DRAFT STAFF REPORT

Volume 2 - Responses To Comments

Glines Canyon (FERC No. 588) and Elwha (FERC No. 2683) Hydroelectric Projects, Washington

FINAL ENVIRONMENTAL IMPACT STATEMENT
VOLUME 2 - RESPONSES TO COMMENTS

Figure 3-15. Generalized land uses in the project vicinity. (Source: the staff).

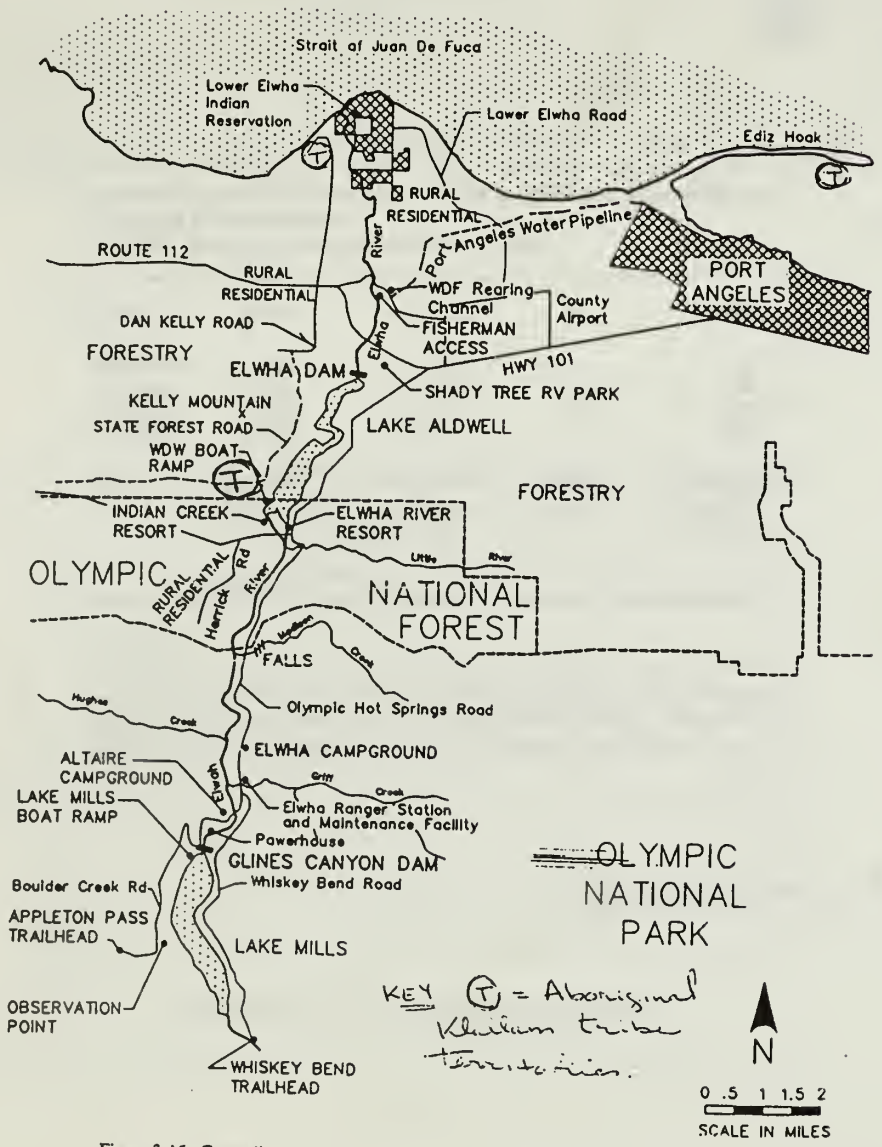
DOI-290 | Figure 3-15., Page 3-74.:
The ONP boundary should be shown extending to Port Angeles along the Heart of the Hills Parkway.

DOI-290: Figure 3-15 has been modified as indicated.
